**PRELIMINARY DRAINAGE REPORT**  
for  
**THE COMMONS AT FALCON FIELD**

**June 29, 2023**

**PCD FILE NO. SP-232 ●**

# Sheet 4-29

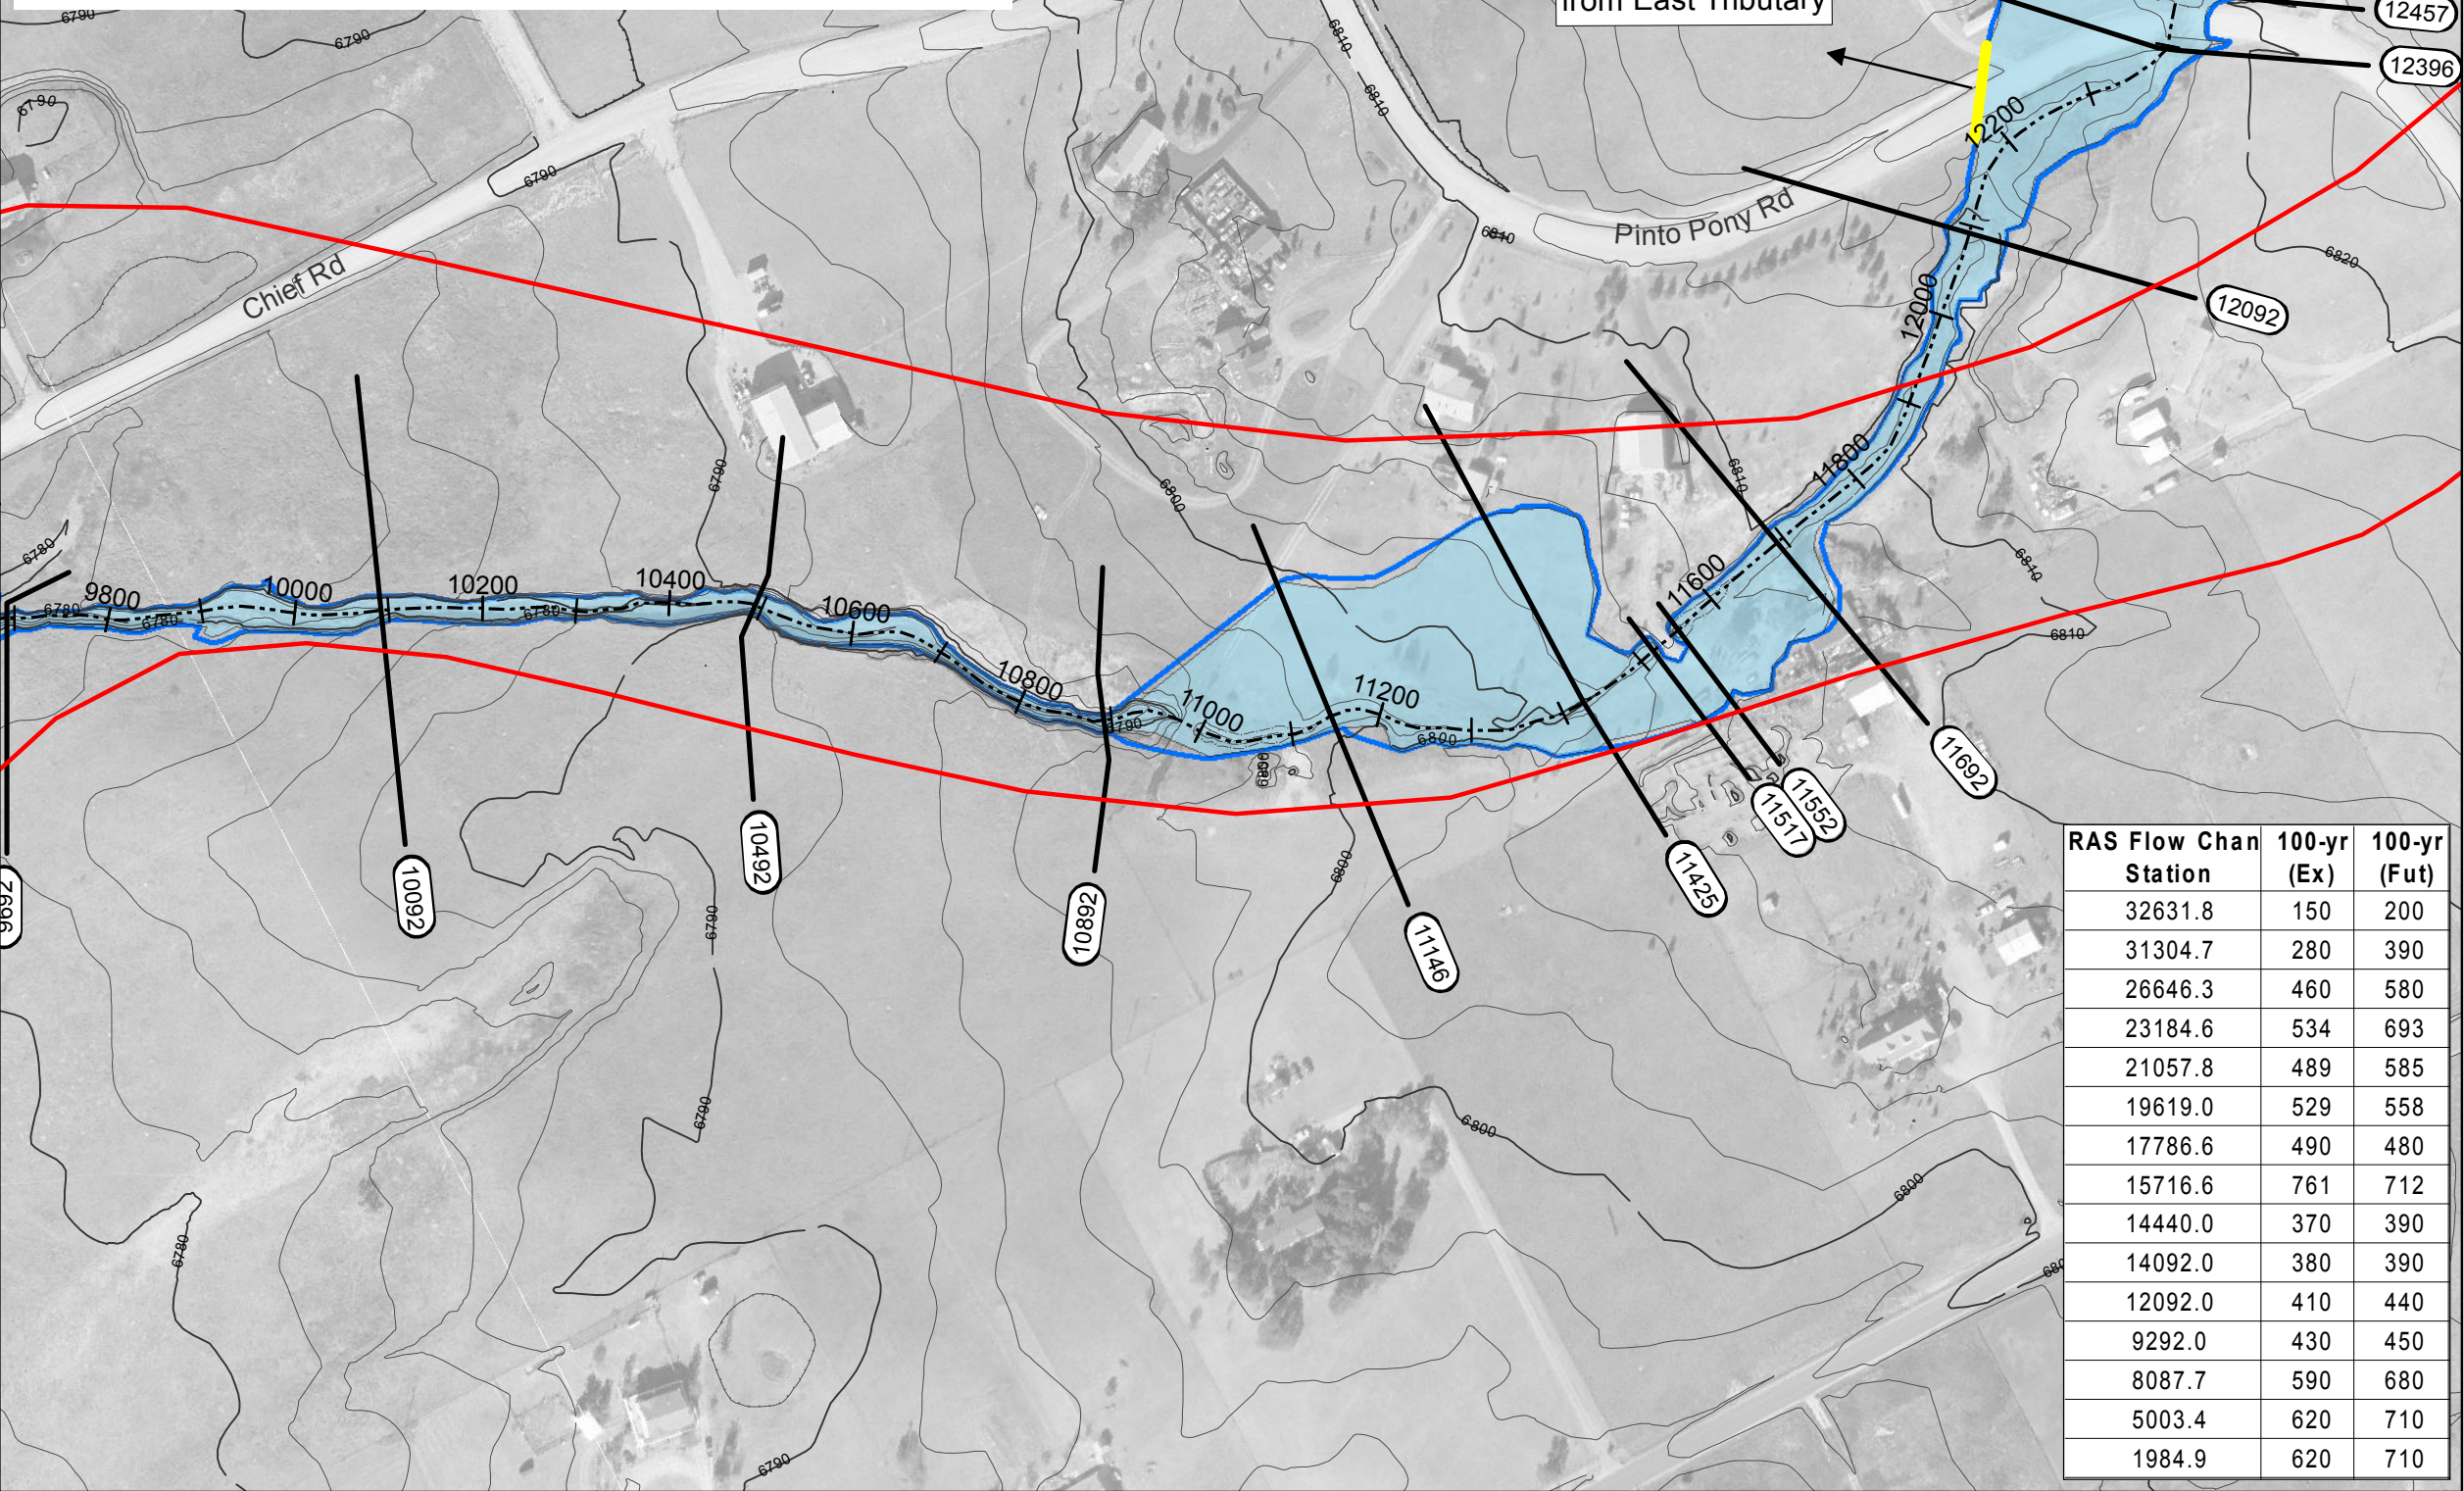
also include 4-28 and Figure 6-1  
<https://epcdevplanreview.com/Public/ProjectDetails/144948>  
<https://epcdevplanstorage.blob.core.windows.net/project/88e3cc80-e965-4ef9-a059-b9808eb384a2/182ddb7f-1f5e-4cb6-9a00-9649cfc365ec.pdf>

# Sheet 4-30

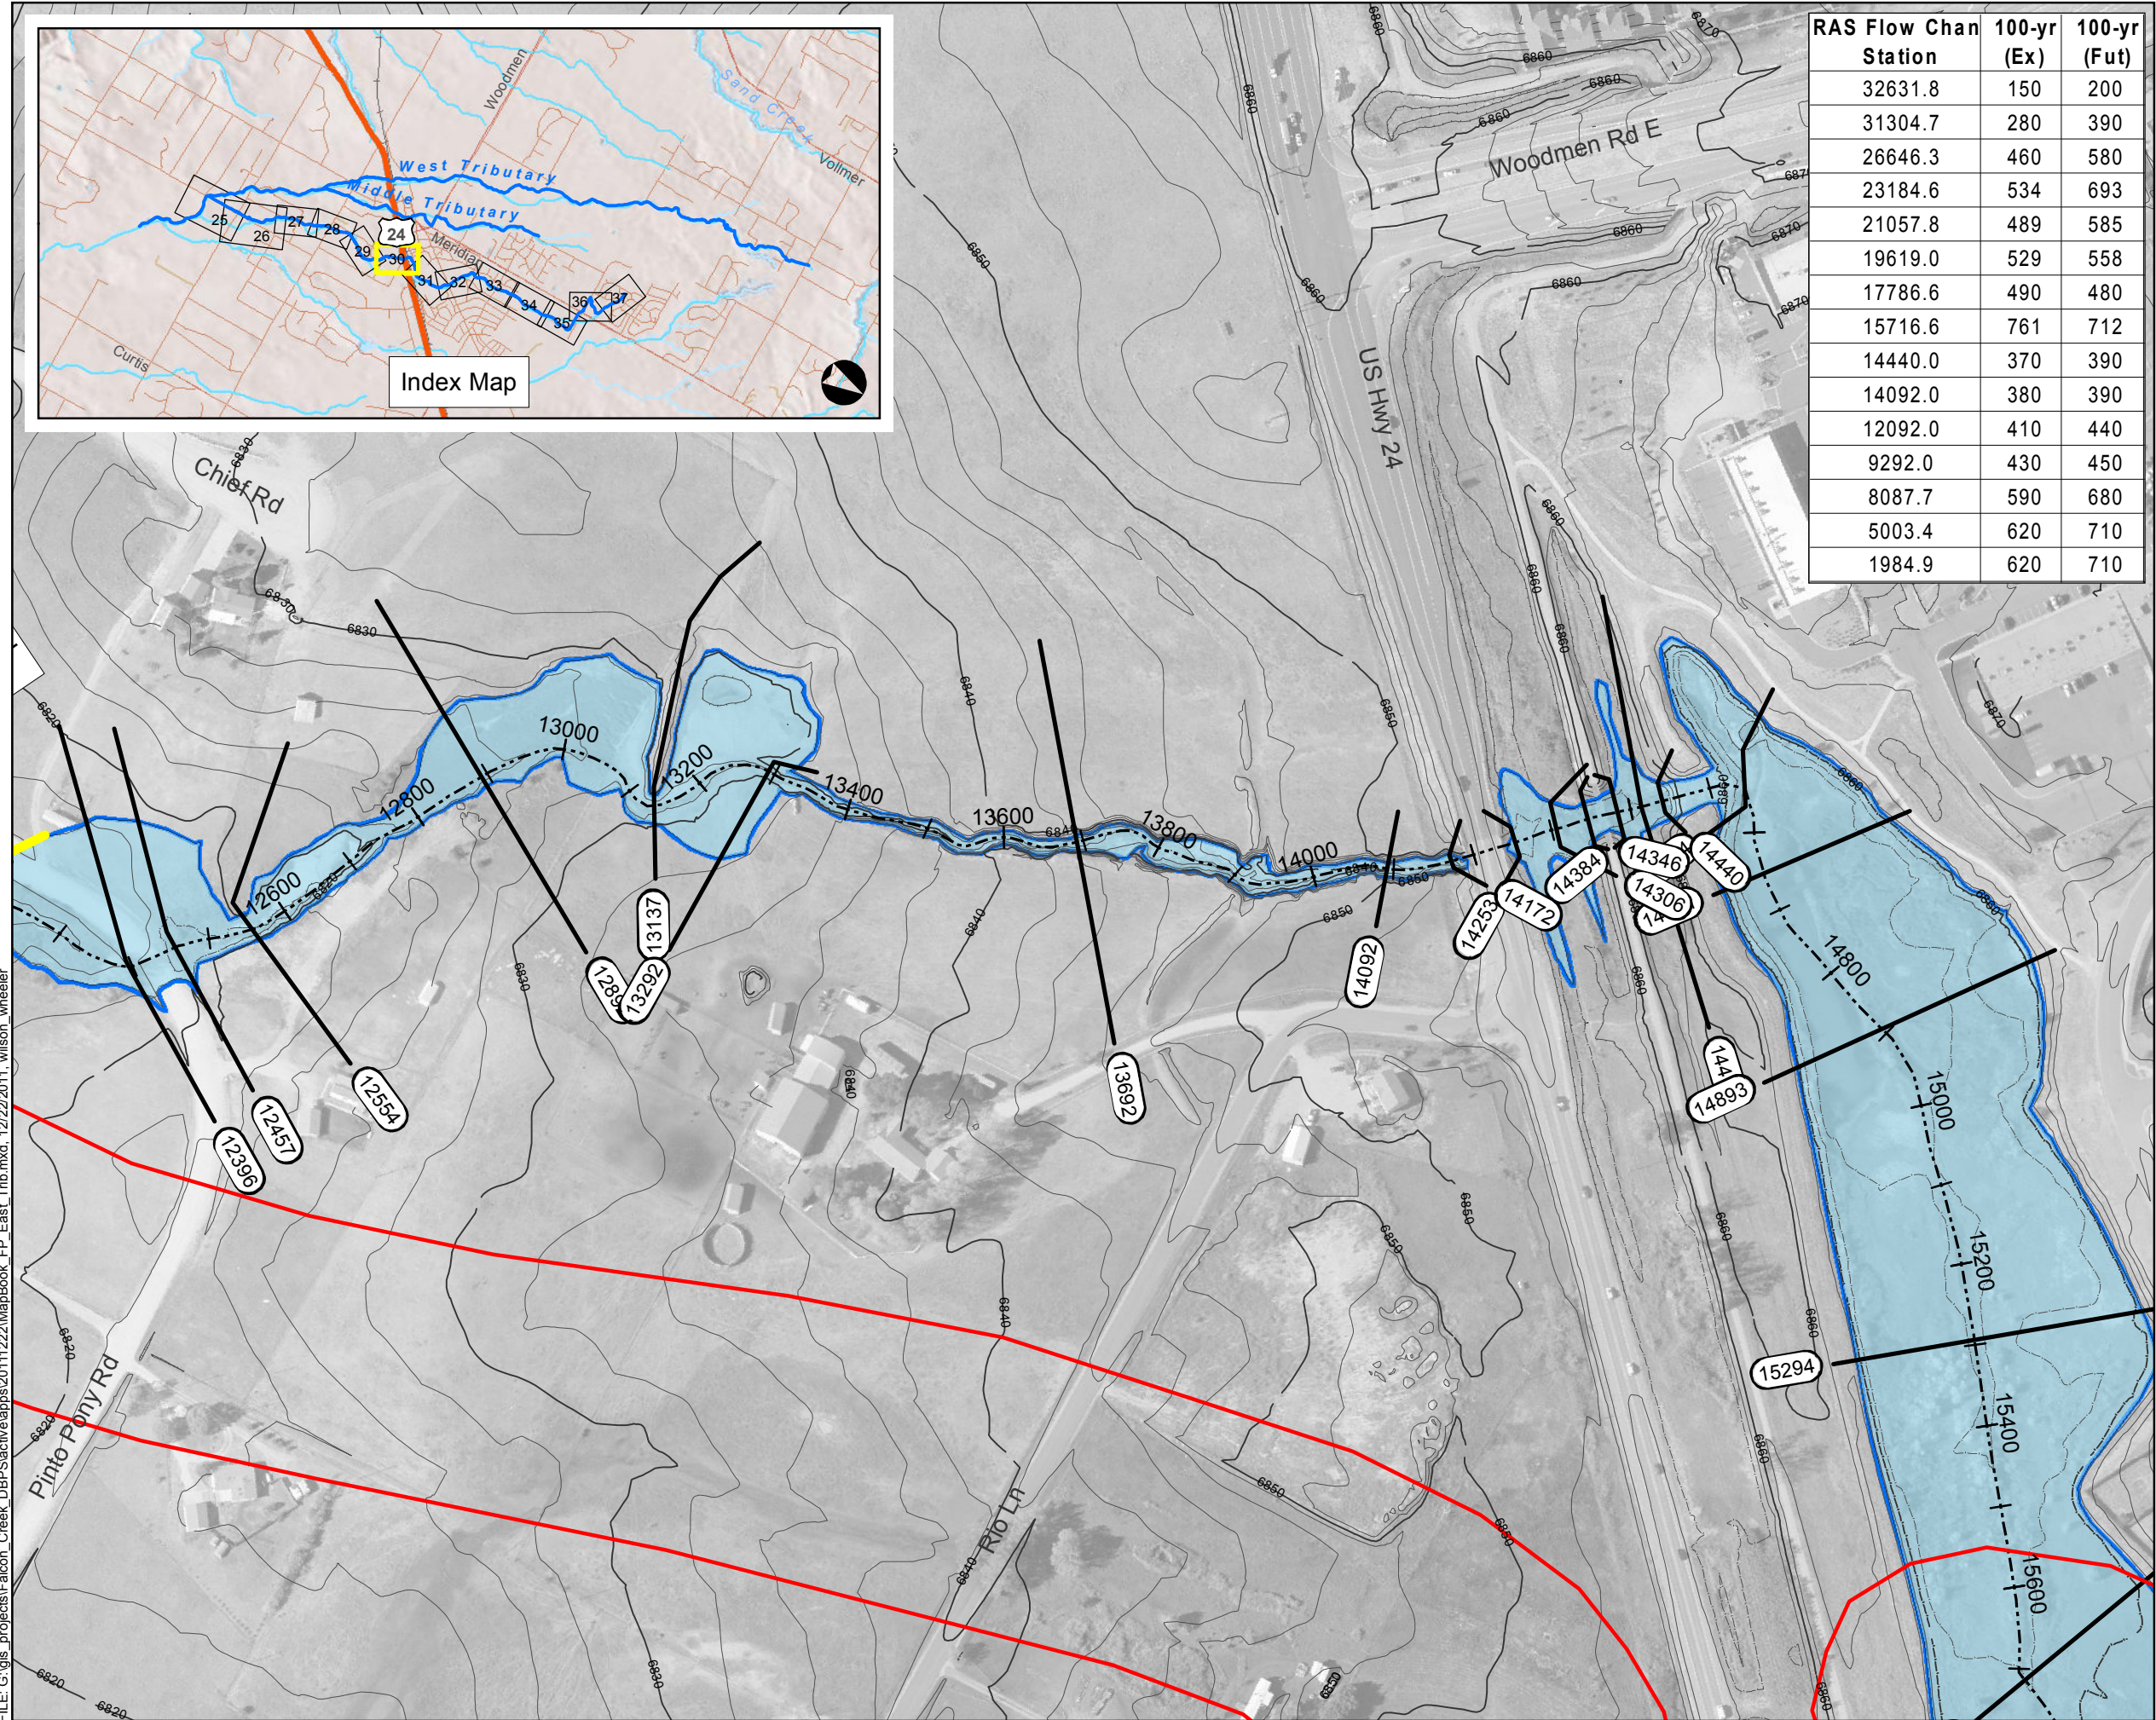
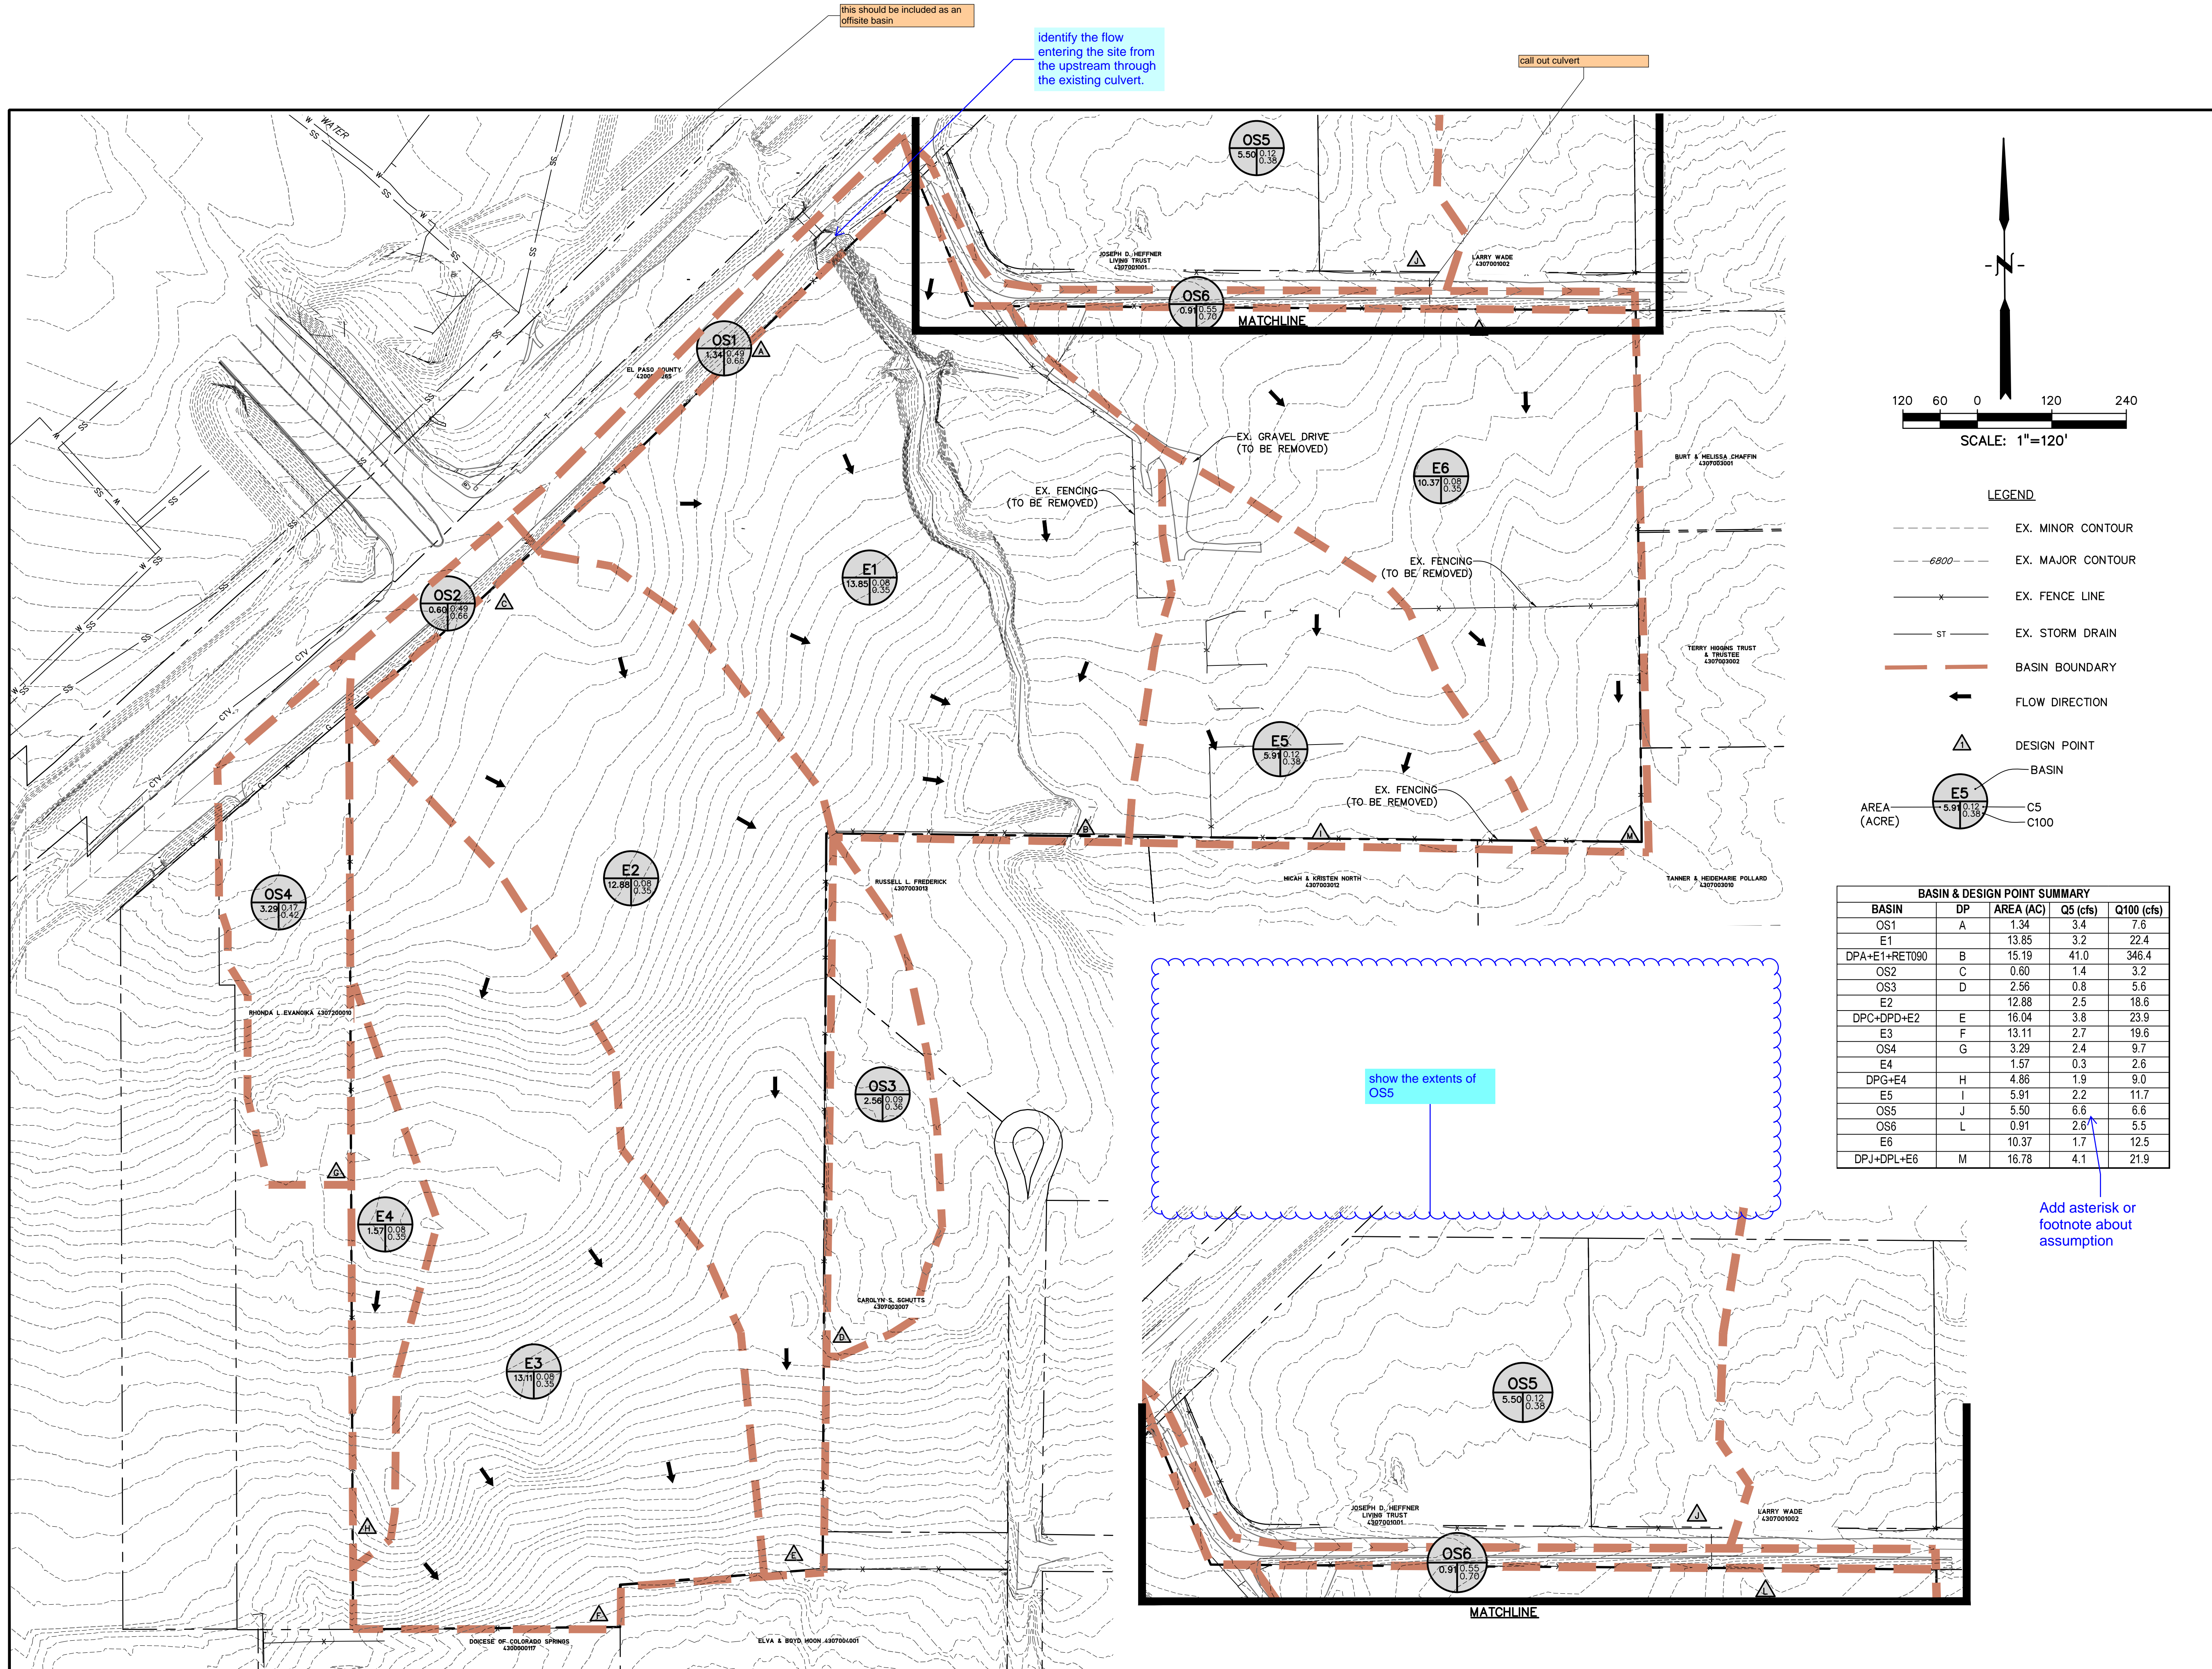
this should be included as an offsite basin

identify the flow entering the site from the upstream through the existing culvert.

call out culvert

show the extents of OS5

Add asterisk or footnote about assumption
